# 1986 - 1987 Corvette: Service Bulletin: Convertible Top Number 5 Bow Weatherstrip Loose

**Subject:** Convertible Top Number 5 Bow Weatherstrip Loose

**Bulletin Number:** 87-148, Number 10

NUMBER 5 BOW WEATHERSTRIP

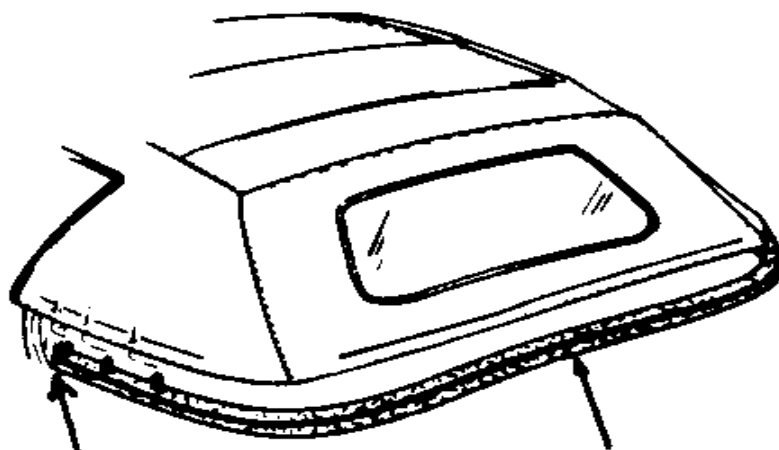
Comments have been reported that on some Corvette convertibles, the number 5 bow weatherstrip pulls loose from the bow at the front ends. Effective with start of 1987 production, the source used an adhesive which eliminated this problem on 1987 vehicles.

FRONT ENDS OF WEATHERSTRIP  
PULL LOOSE AND FOLD BACK.  
MAKE SURE ADHESIVE IS APPLIED  
ALL THE WAY TO THE FRONT END OF WEATHERSTRIP.

Field repairs can be accomplished by gluing the weatherstrip ends down with 3M weatherstrip adhesive, P/N 08011, or P/N 12345096-7 weatherstrip adhesive. (See illustration). Before applying adhesive wipe the weatherstrip with alcohol or all purpose adhesive cleaner to remove any mold release compound. Care should be taken to make sure the adhesive is applied all the way to the extreme forward ends of the weatherstrip. Also, be sure the plastic nails are installed properly. If the weatherstrip is damaged, it will have to be replaced.
